Wiring Fastening for Clutch Actuator on ASTRONIC Transmissions

During the course of further development work, the wiring fastening for the clutch actuator was modified. The two retaining plates, to which the cable harness was previously attached by means of cable clips, were discarded in two modification stages. They have been replaced by cable clamps. A modification related to this has also been undertaken on housing section 2. The new housing section 2 has been introduced to volume production by modifying the parts list and using new item numbers.

New Splitter Group Synchronizer Unit in ASTRONIC Transmissions

New Housing Seals in ASTRONIC 2 Transmissions

Fastening for wiring (underside of transmission, second modification stage)

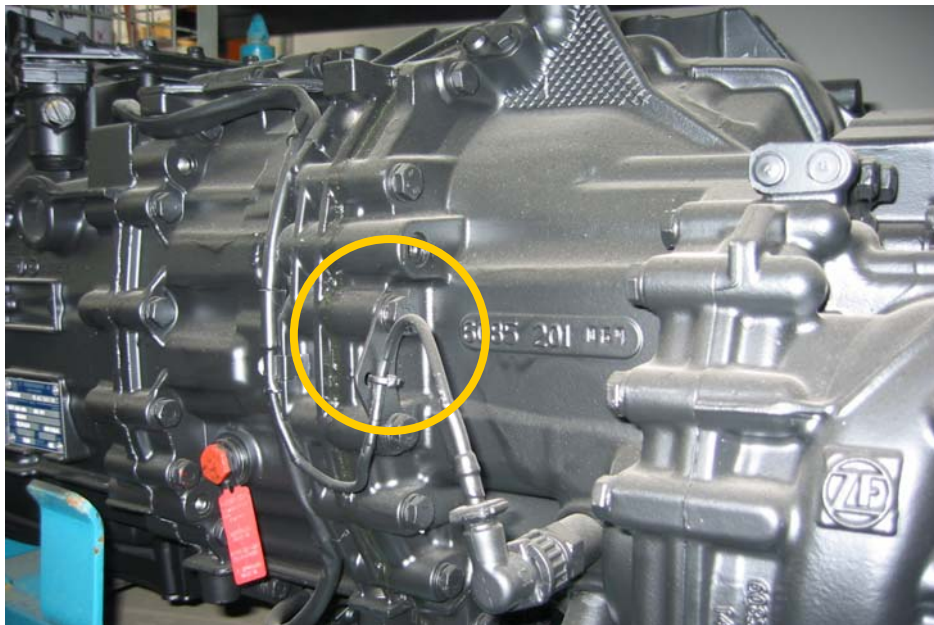
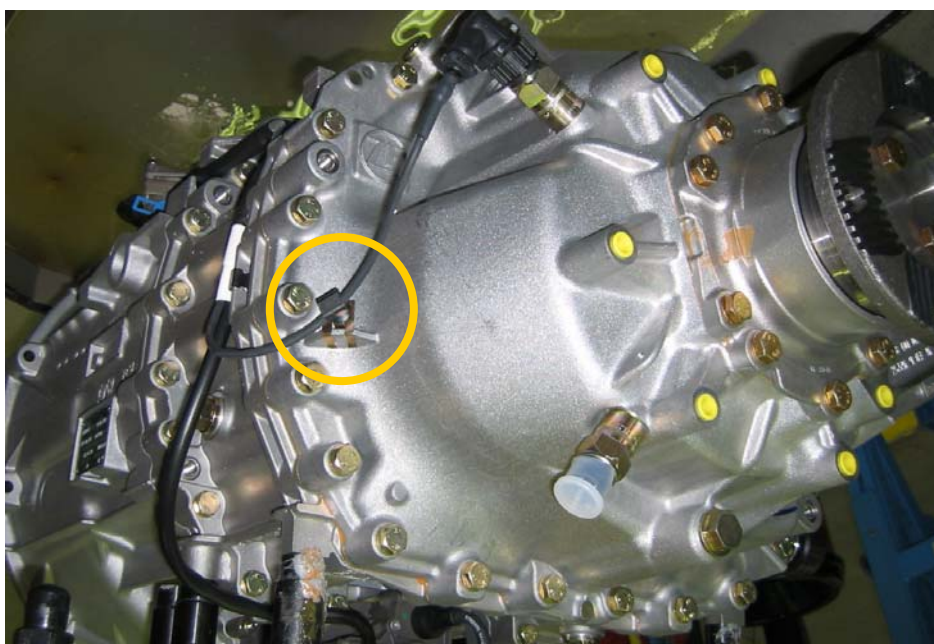
OLD fastening of wiring

Fixing device
1328 301 052

NEW fastening of wiring

Fastening
0501 214 086

Modified point on housing 2

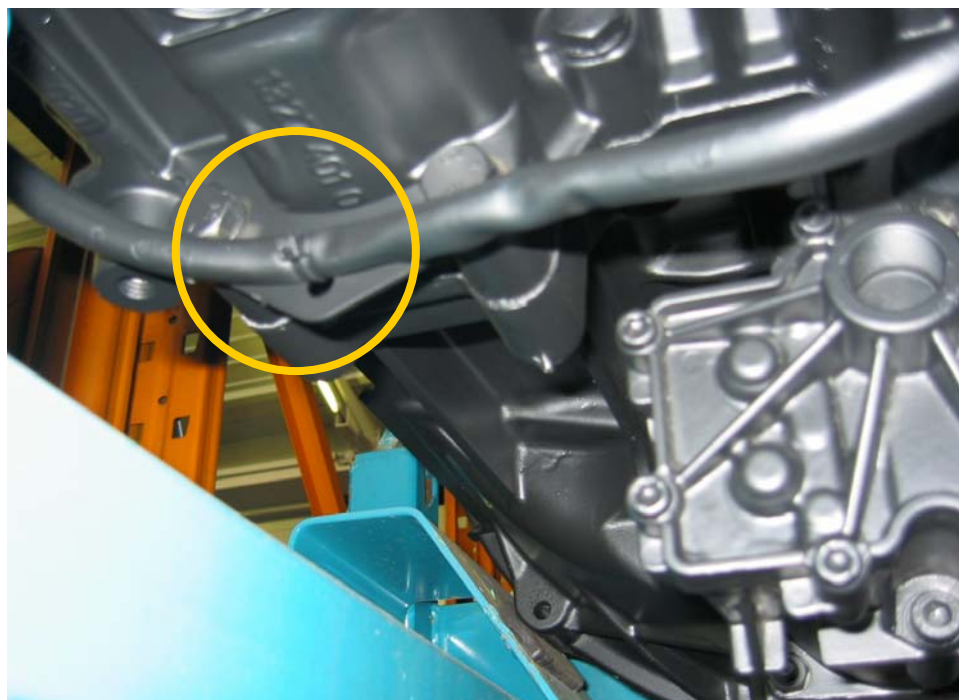
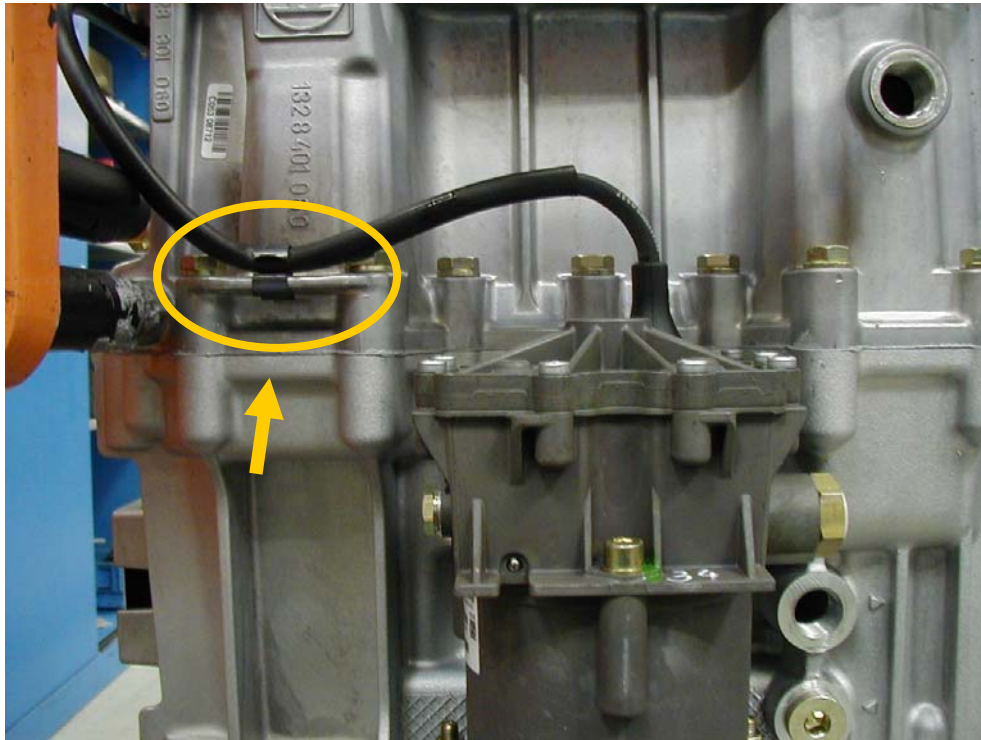
OLD

Fixing device
1328 301 052

NEW

Cable clamp 0659 050 410

Sample sketch of installation situation of splitter group synchronizer unit in ASTRONIC 2 transmissions

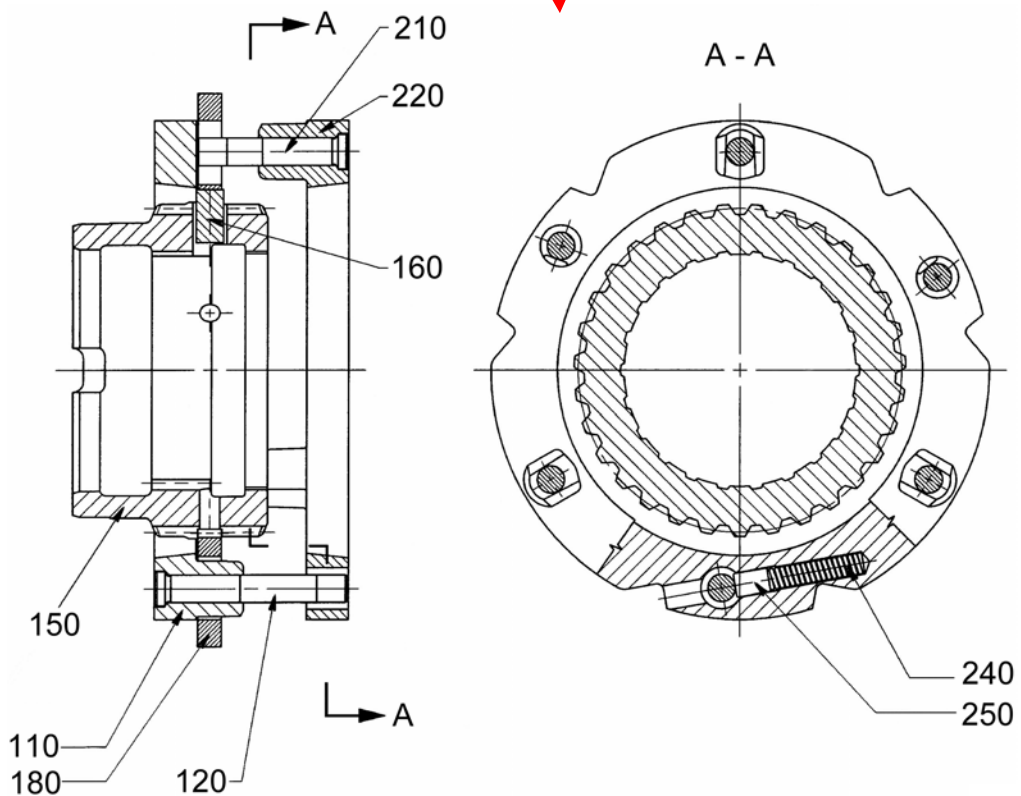
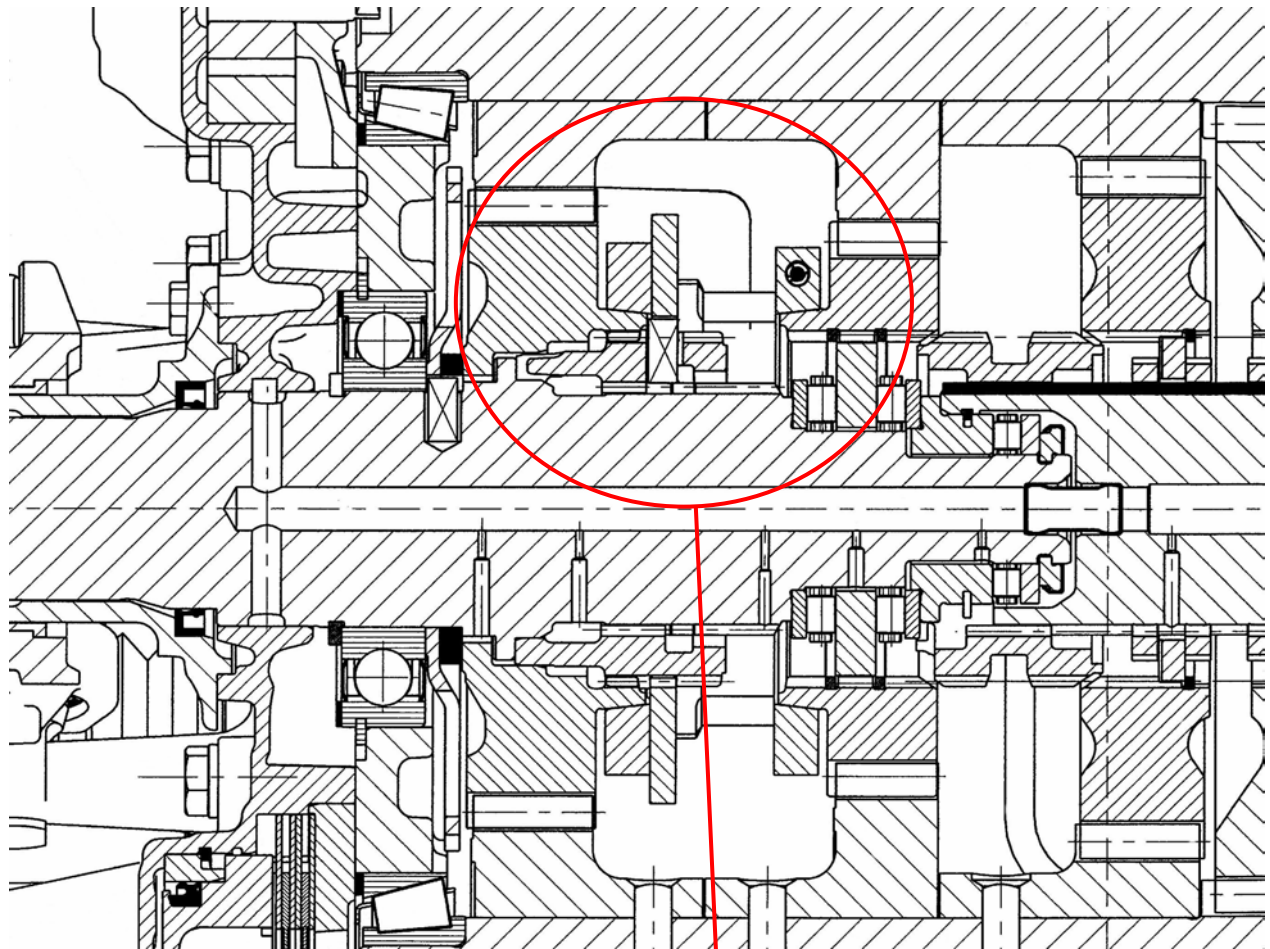
During the course of further development work, the splitter group synchronizer unit in the ASTRONIC 2 transmission has been further optimized. The design of the synchronizer rings and plate has been changed. To ensure uniformity, the synchronizer rings and plate of the synchronizer unit in the ASTRONIC 1 transmission have also been modified.

In the event of repairs, the synchronizer rings and plate should always be replaced in complete sets. Old and new components must not be combined with one another. Old parts may be used up.
